Submission of Further Information (FI)

**Proposed Temporary Private Vehicle Park (Private Cars Only)
for a Period of 3 Years in "Village Type Development" Zone,
Lot 343 (Part) in D.D. 113, Kam Tin, Yuen Long, New Territories
(Application No. A/YL-KTS/1090)**

Further Information for Planning Application No. A/YL-KTS/1090**Response-to-Comments****Comments from the Drainage Services Department**

1:500 (A3)	Drainage Proposal	Goldrich Planners & Surveyors Ltd.
November 2025	Lot 343(Part) in D.D. 113	Plan 5.1a (P 25040)

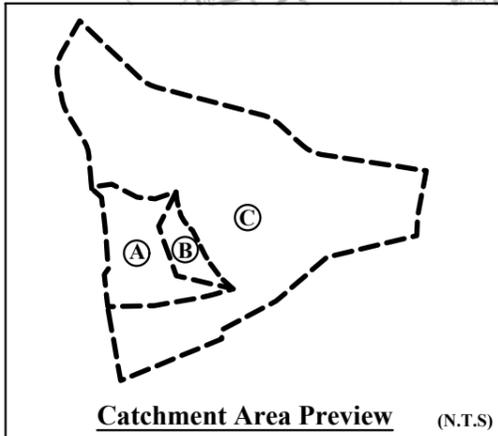
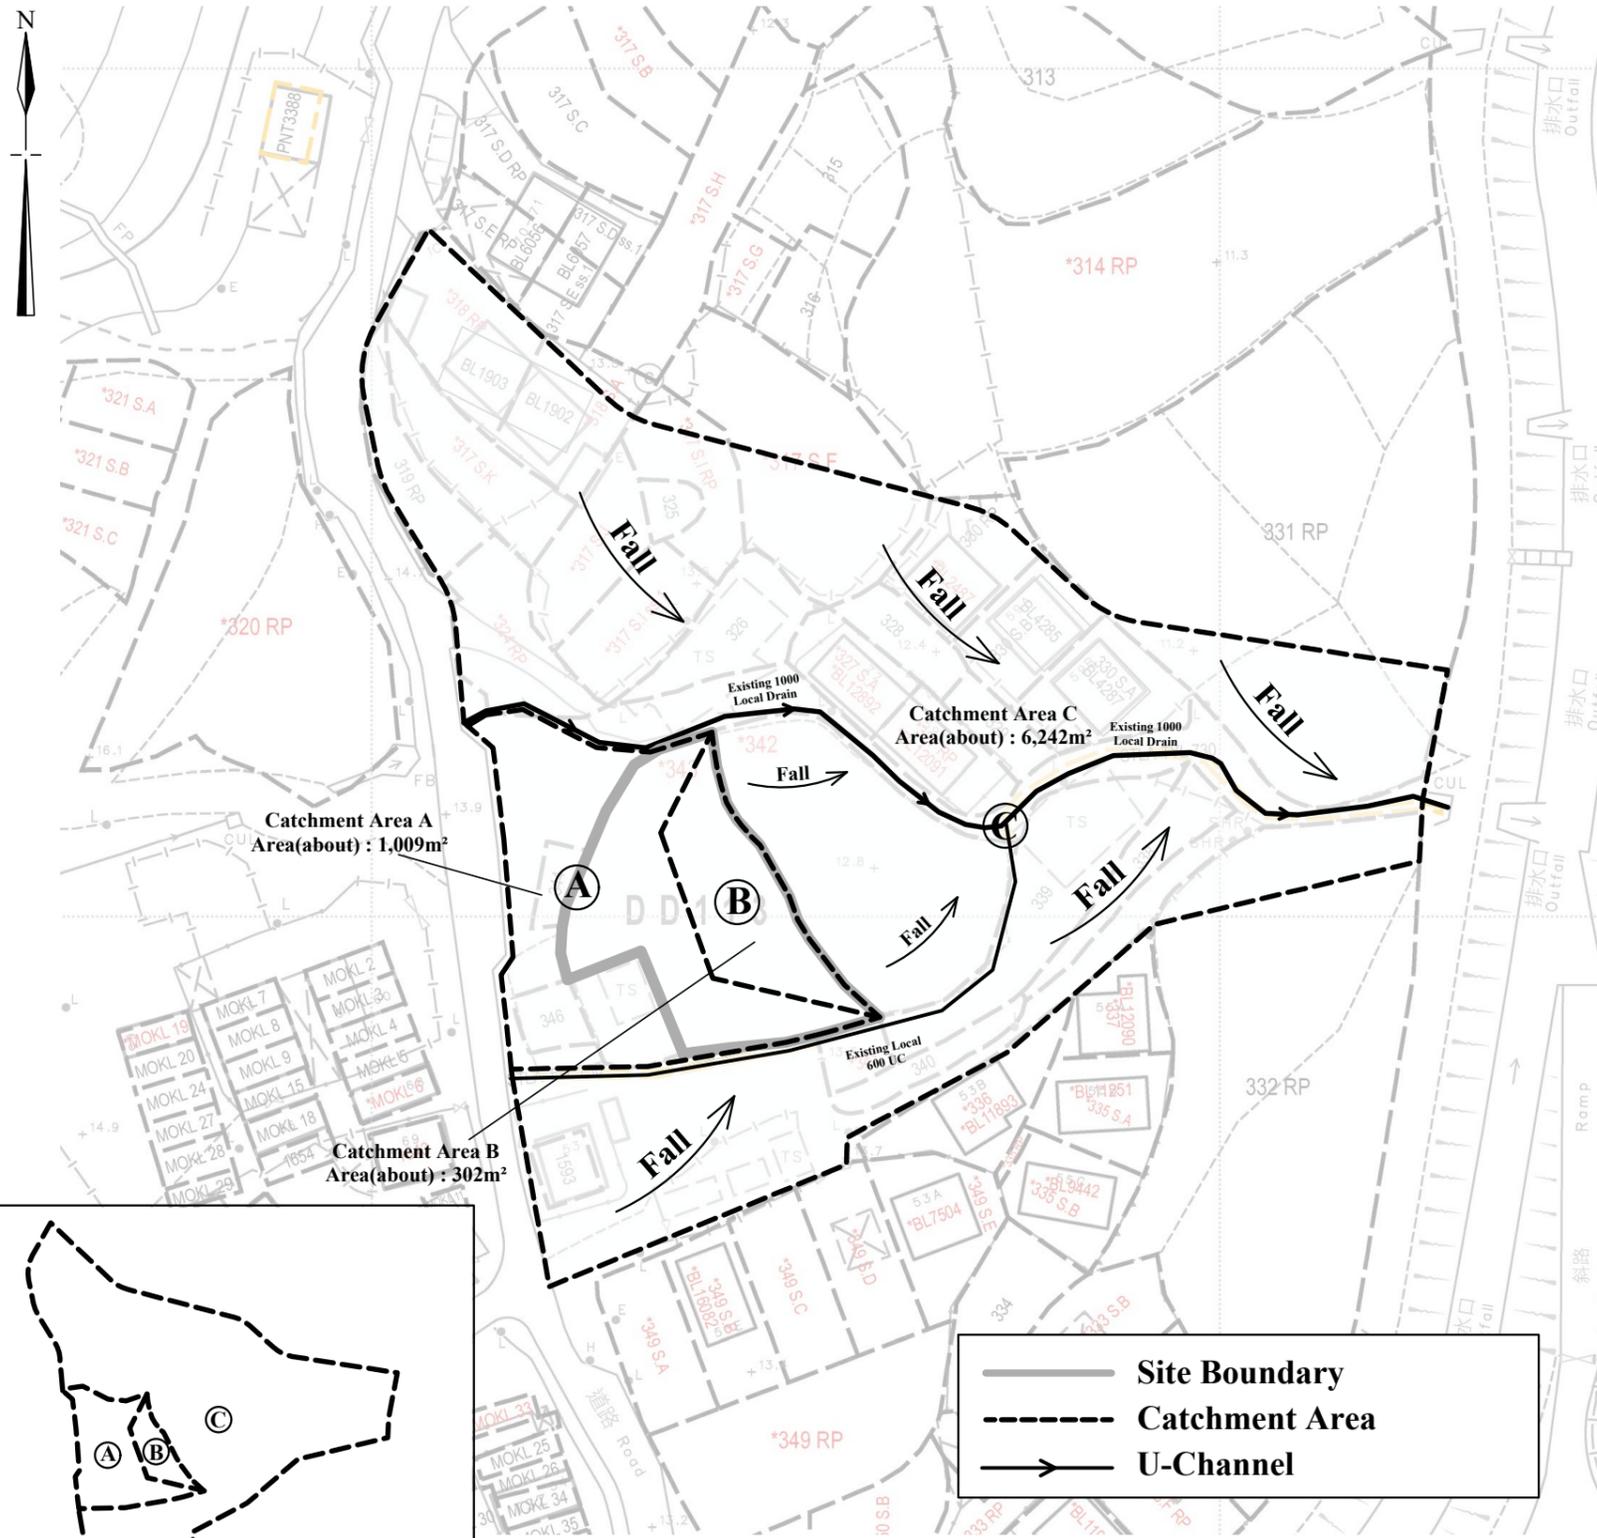
I.	Comments	Responses
1.	Referring to item 2 of the R-to-C provided, it is noted that all the proposed works will be placed 3m away from the top of the bank of the channel. Please clearly state the above on the drainage plan (Plan 5.1a) for record.	Noted. Please refer to Plan 5.1a.

3.	The details of the proposed 100mm gap at the toe of the hoarding should be shown on the drainage plan (Plan 5.1a instead of Plan 5.2a) for clarity.	Noted. Please refer to Plan 5.1a.

4.	Please advise if any site formation/levelling works to be carried out under this application. Cross sections showing the existing and proposed ground levels of the captioned site with respect to the adjacent areas should be given.	No site formation/levelling works to be carried out under this application. Please refer to Plan 5.1a.

Plan 5.2a
(P 25040)

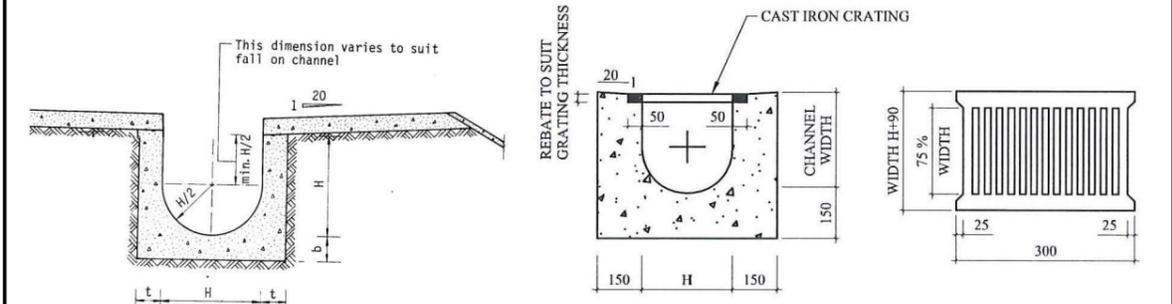
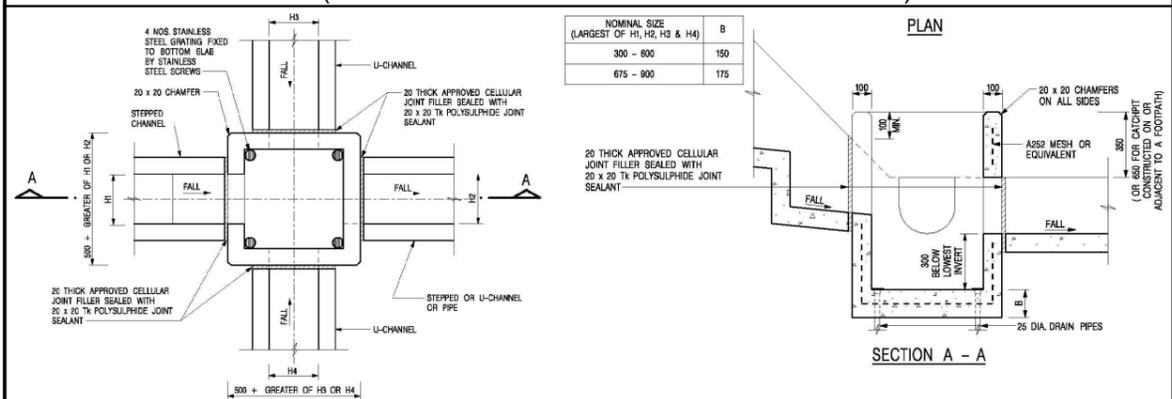
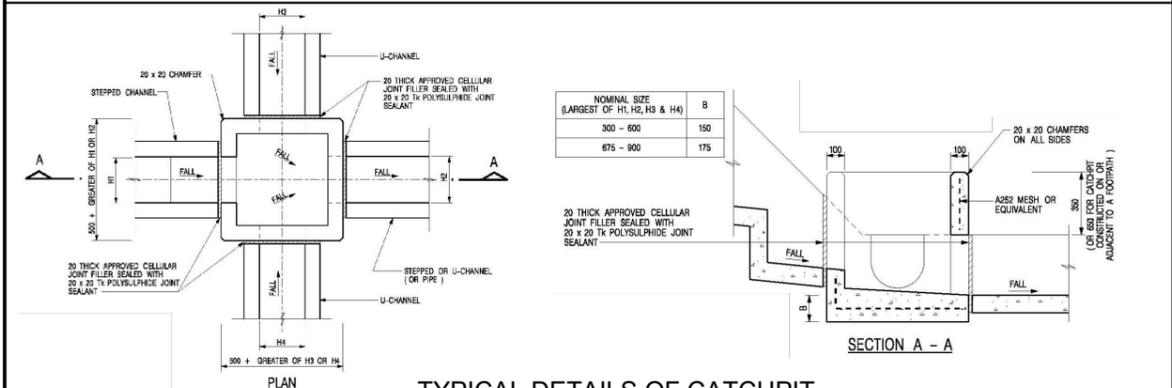
2.	Please provide site photos to demonstrate its presence and internal condition of the existing 300mm u-channel located at the western side of the application site for review.	Please refer to Viewpoint Photographs.
